Gachsaran Polymer Industries Company HDPE Plant		
	Instruments Hookup Diagram and MTO	 	
PO No.: GPIC-PT-MA-PO-000-3029	Document Number: VD-GPIC-MA-3029-3029-0051	Rev. 00	Page 1 of 17

Instruments Hookup Diagram and MTO

Page 3 of 17

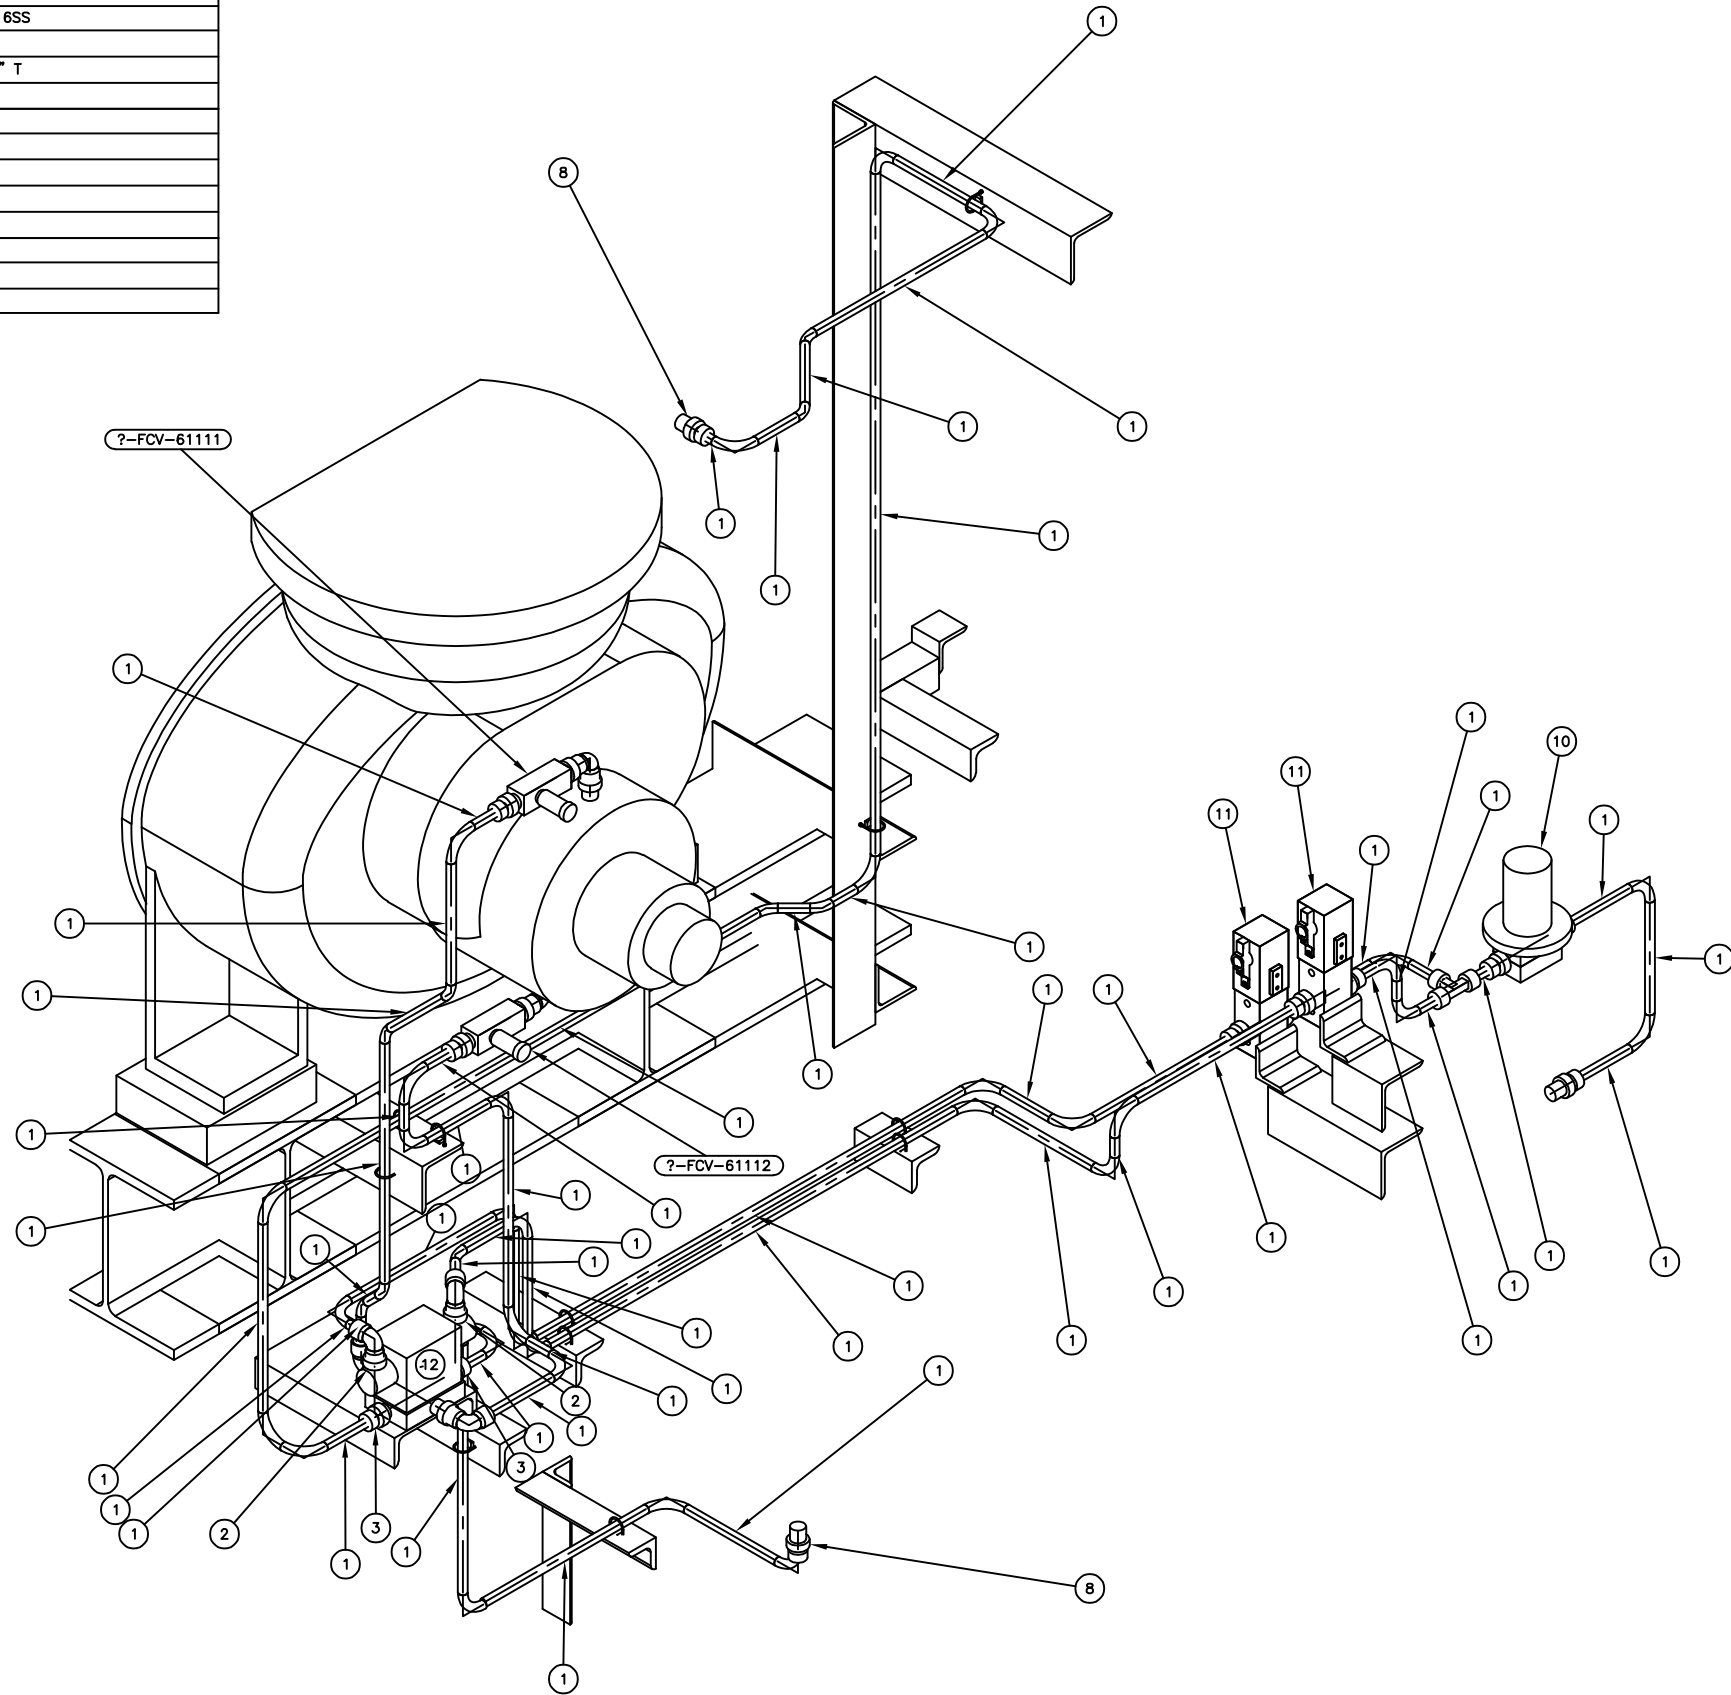
IN-01. All items of hookup material in the next sheets shall be mentioned in the below table.

- Vendor Reply: Noted

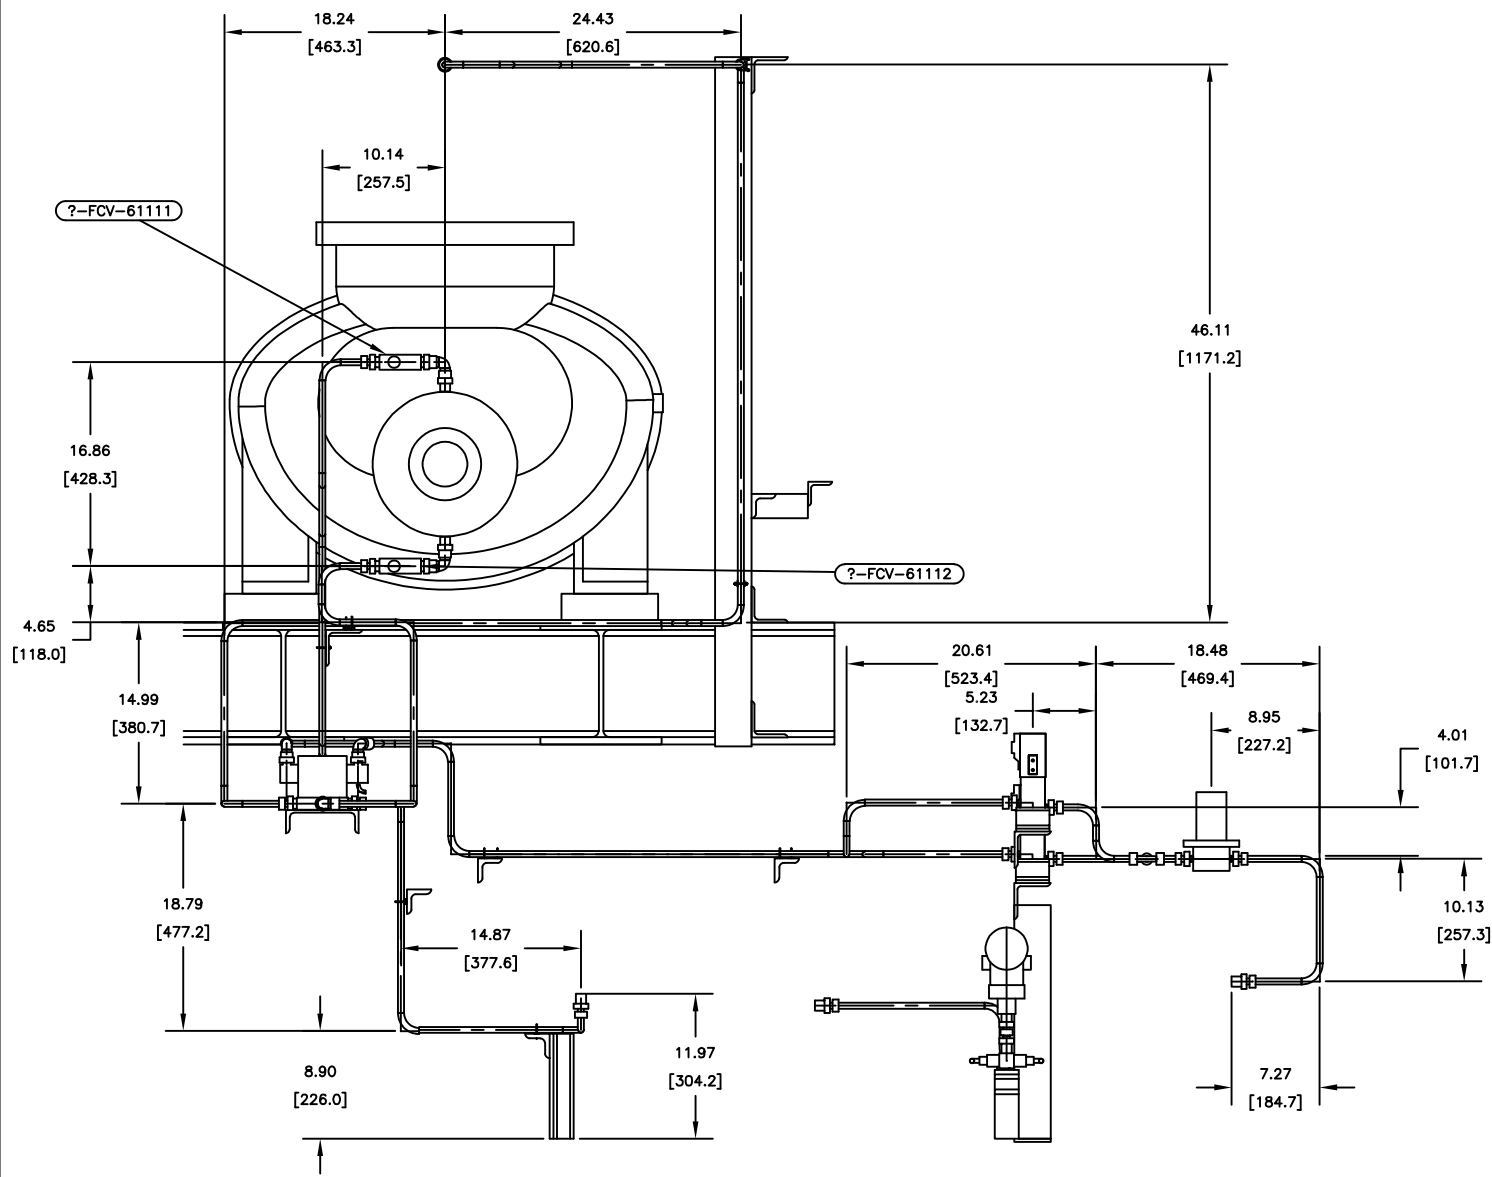
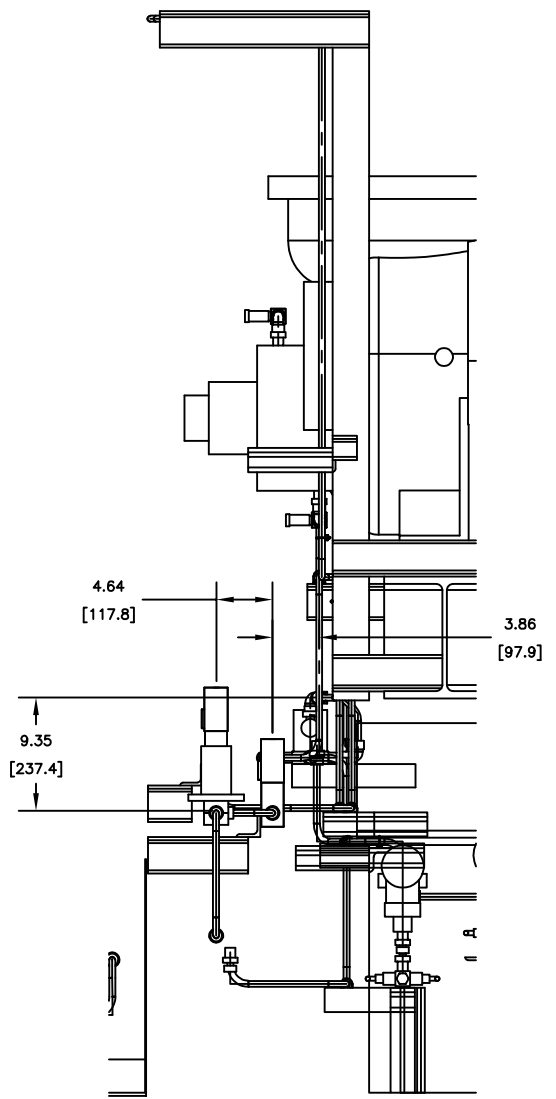
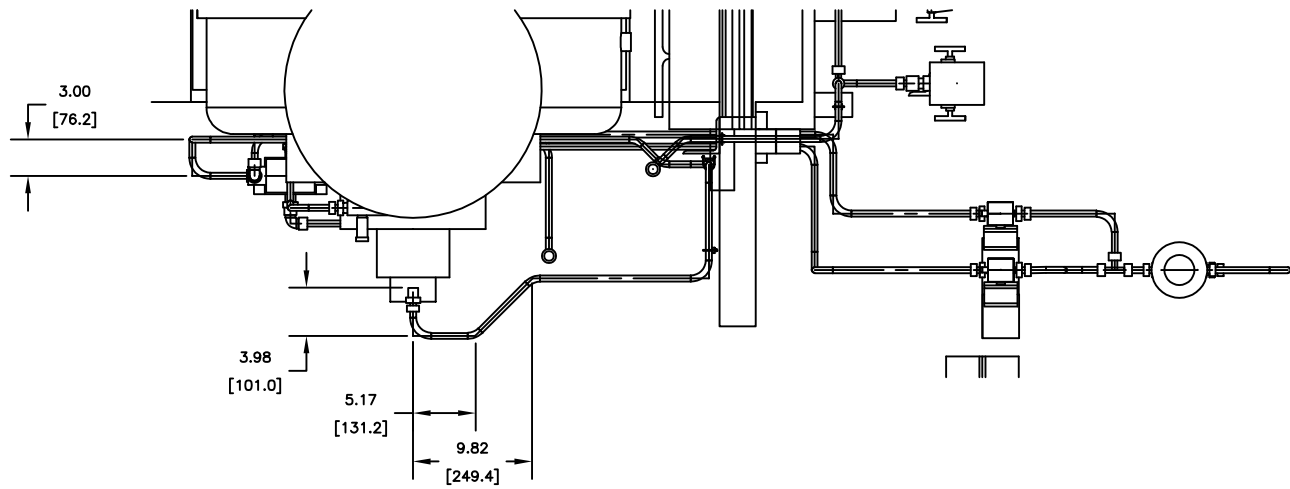
IN-02. Table of MTO is missing in this sheet.
 - Vendor Reply: MTO for this sheet has been specified in previous sheet

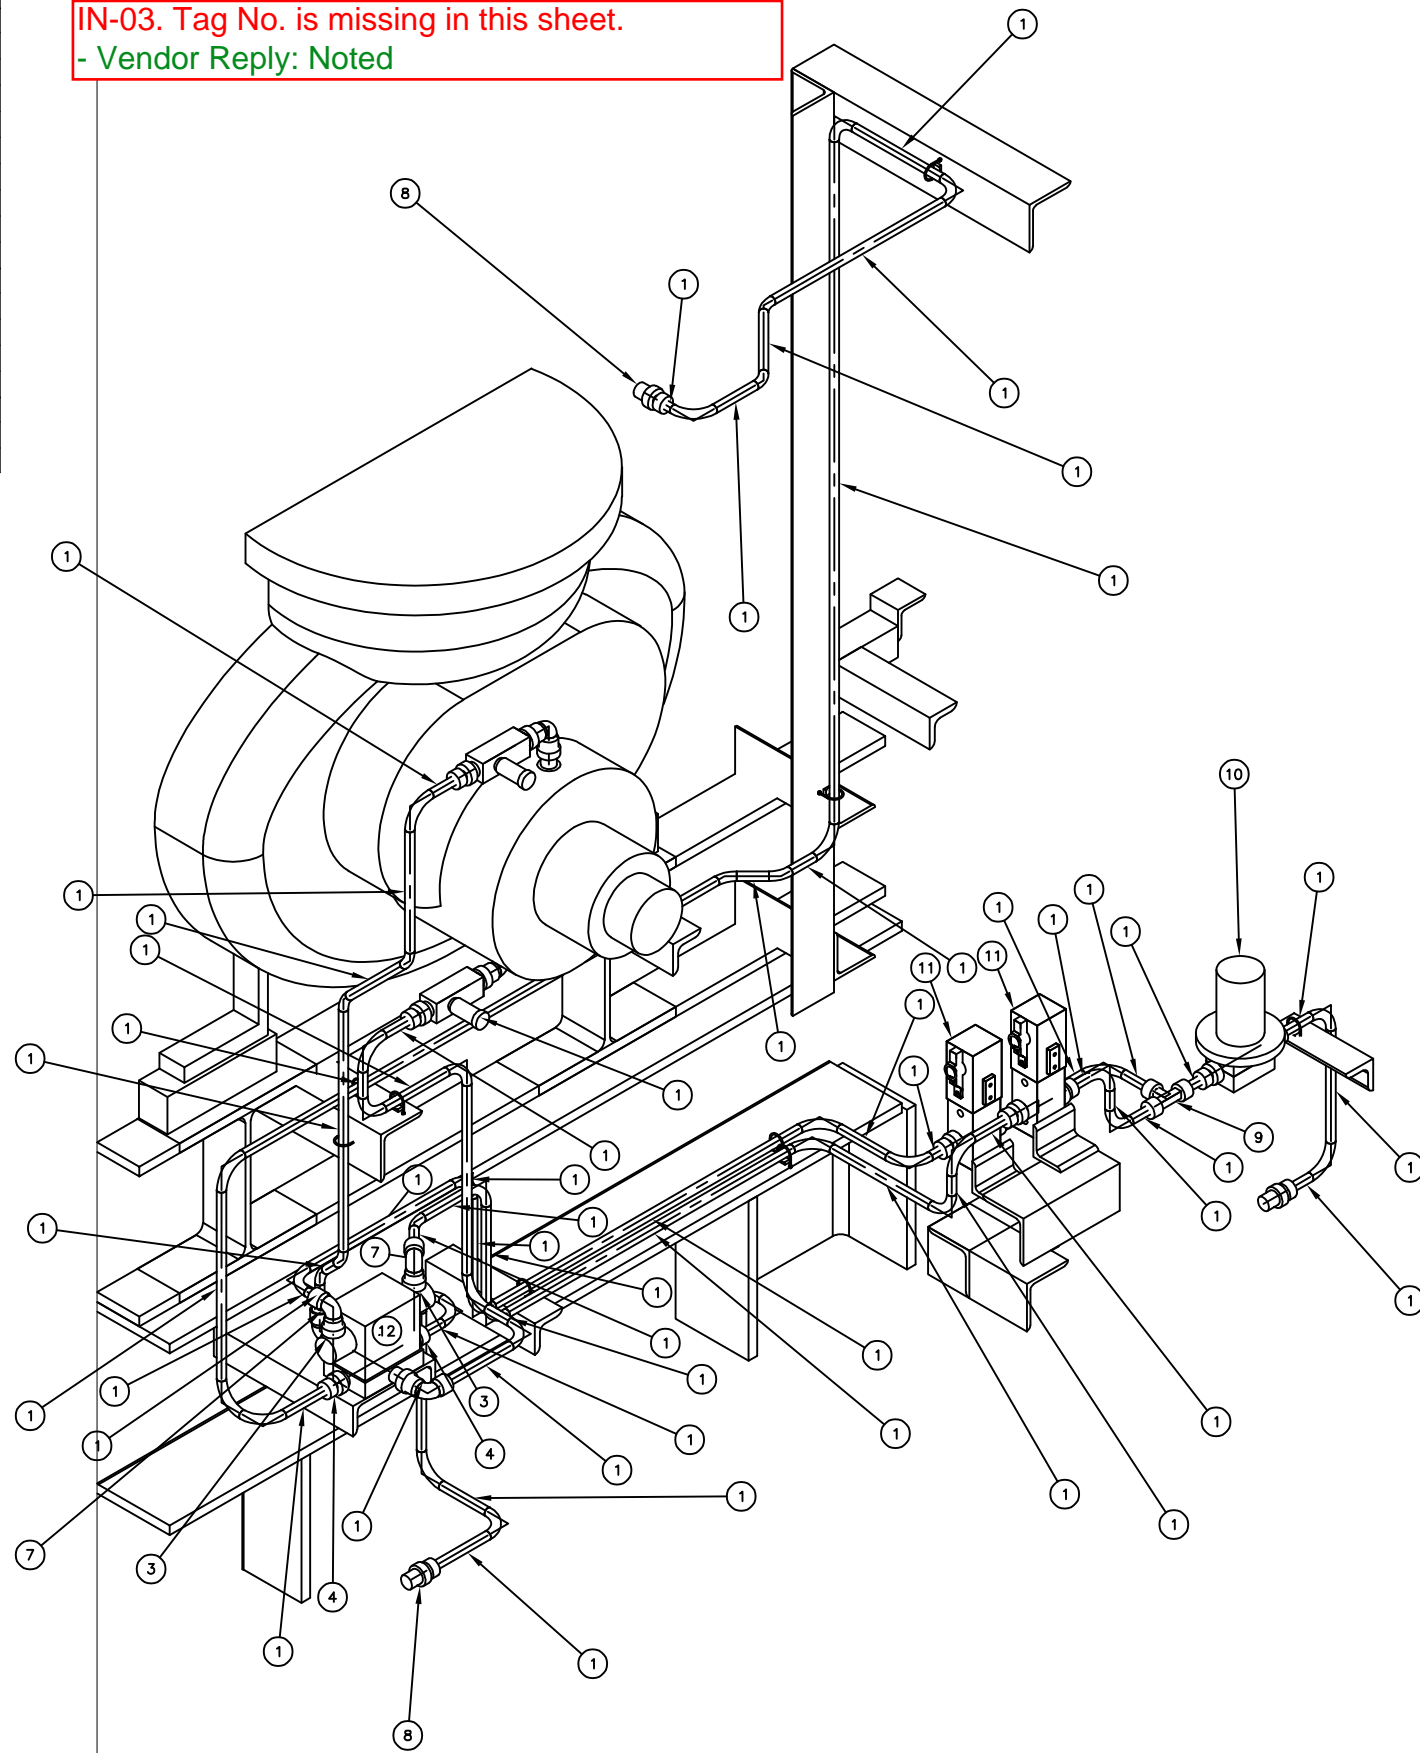
IN-03. Tag No. is missing in this sheet.
 - Vendor Reply: Noted

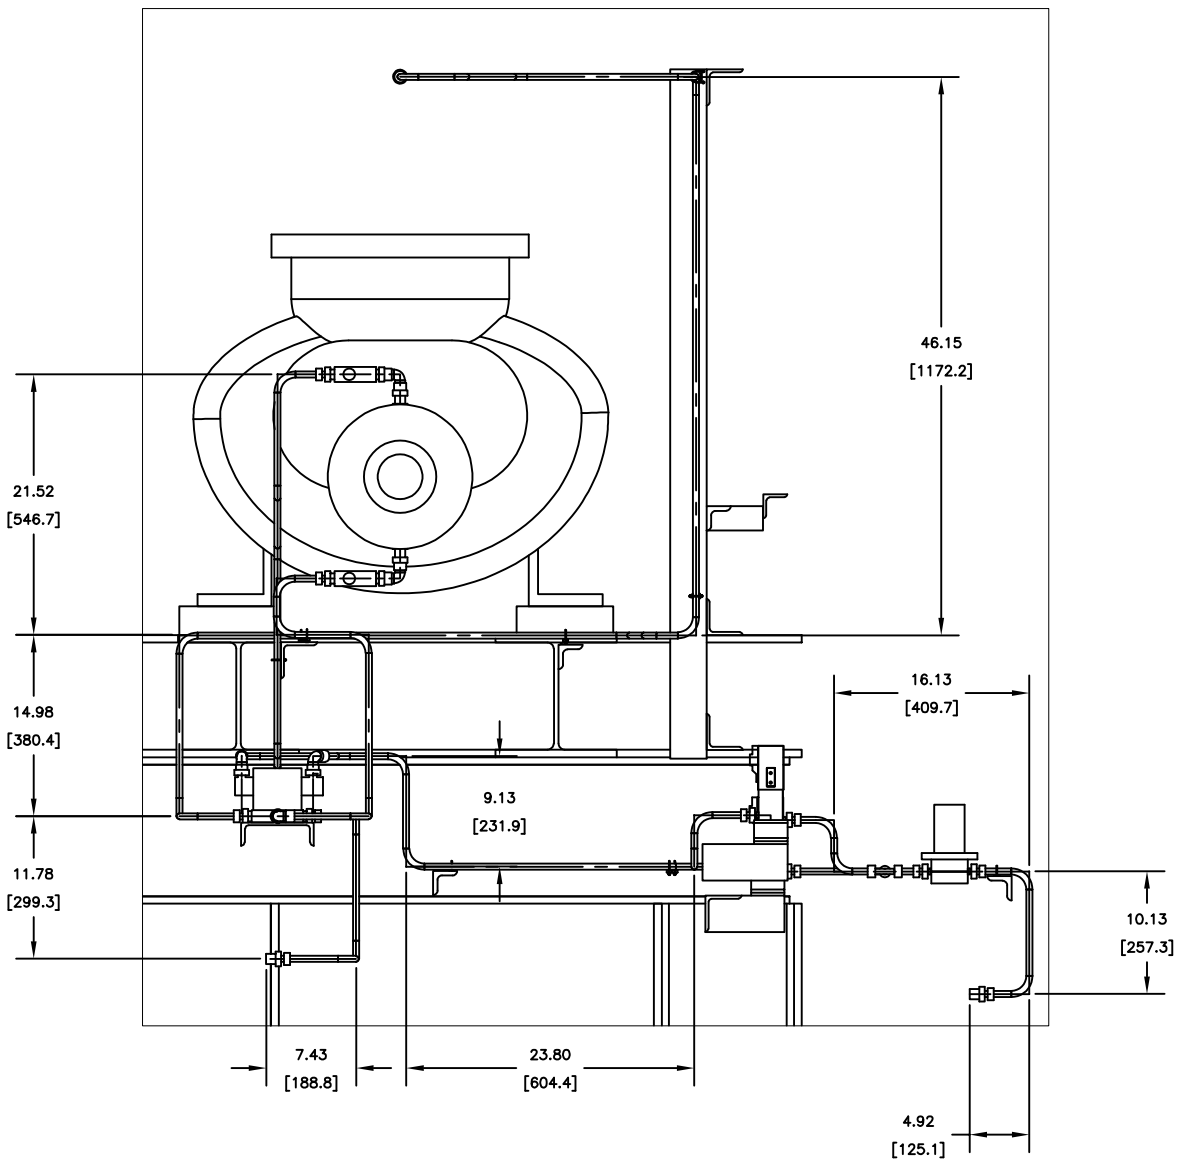
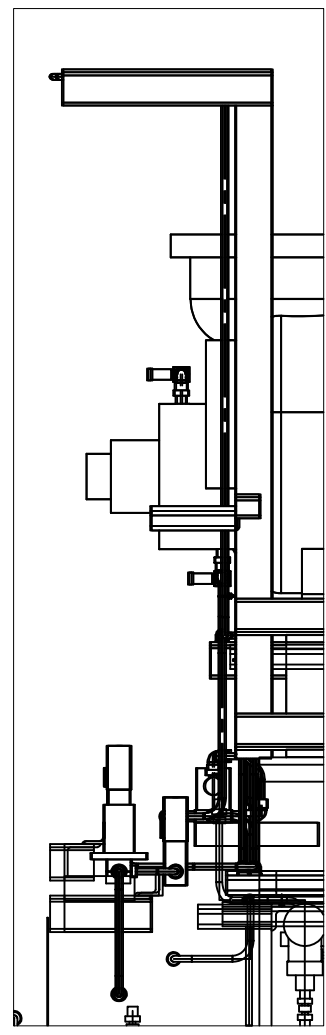
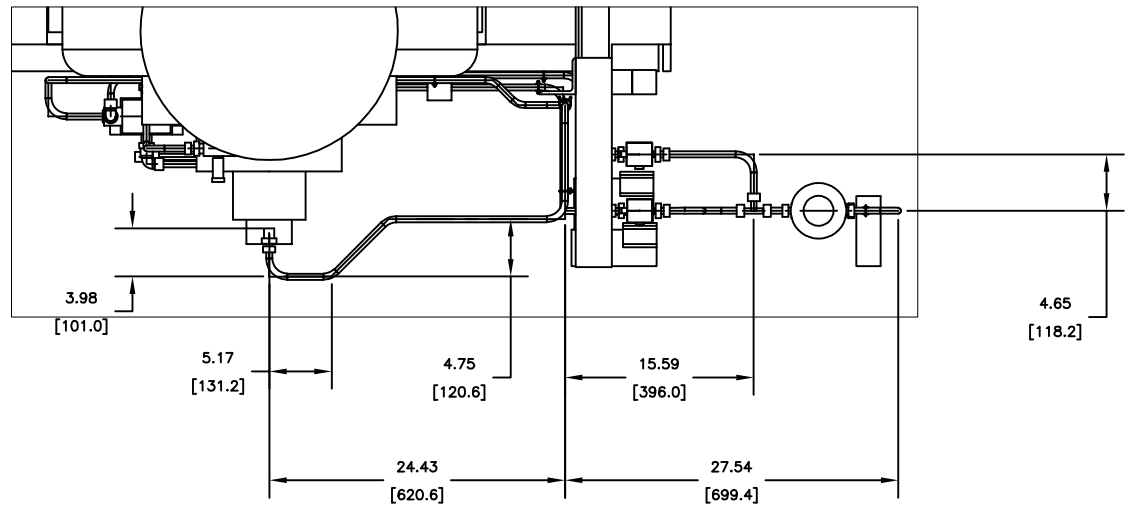
IN-04. Table of MTO and tag no. are missing in this sheet.
 - Vendor Reply: MTO for this sheet has been specified in previous sheet
